2018 Development Services Code

WSSC Commission Meeting

PUBLIC REVIEW COMMENTS RECEIVED with DSG'S RESPONSE

Figure 11.2

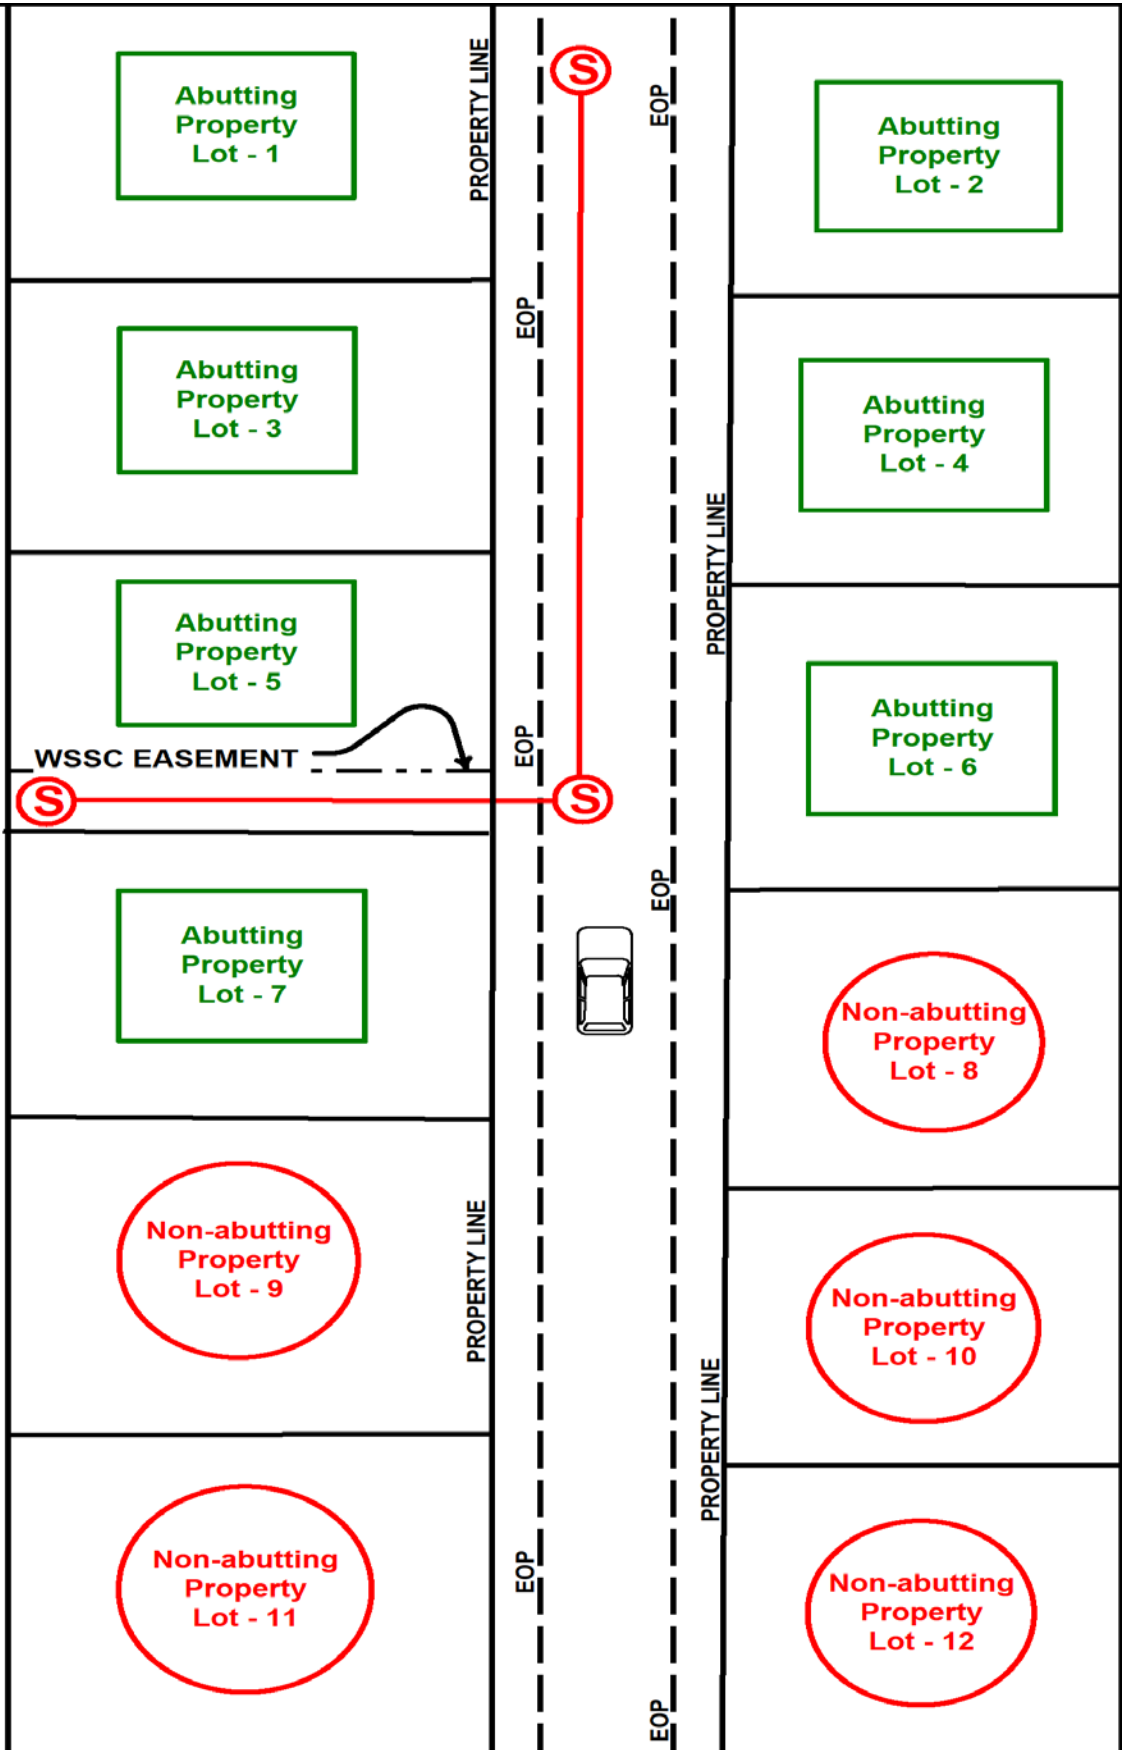
Figure 11.2

DSG Response/Reason: Look at the side property line on Lot 8 and you will see the sewer main does not abut it at any point. The fact that the main is not physically abutting the property at any point means that we will do a non-abutting connection review to determine if an angled connection will be allowed. The sketch will remain as-is.
